UNITED STATES PATENT AND TRADEMARK OFFICE

10/674,421

Gee-Sung Chae

DETAILED ACTION

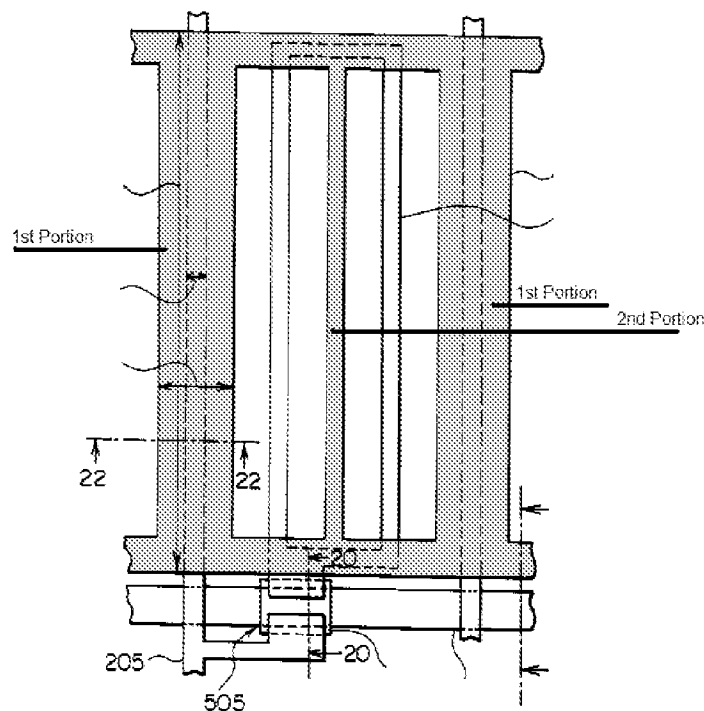
The Examiner again respectfully disagrees. The following relabeled figure 24 of Sakamoto should help illustrate that Sakamoto discloses just the structure that is currently claimed.

As seen above and furthermore discussed in the updated rejections below, Sakamoto is seen as disclosing the newly amended claim limitations. Therefore the rejections are seen as sufficient and are maintained.

a common electrode (305 in fig. 24) in each of the pixels, the common electrode being substantially parallel to the pixel electrode (fig. 24), the common electrode including two first portions (left and right wide portions of 305 in fig. 24) disposed along the data line to cover complete the data line ($W_{com} > W_d$ in fig. 24) and only one second portion (skinny portion of 305 in middle of the pixel in fig. 24) disposed between the first portions (fig. 24), thereby each of the pixels including two areas defined by the first portion and the second portion (fig. 24 shows two different areas as here defined);
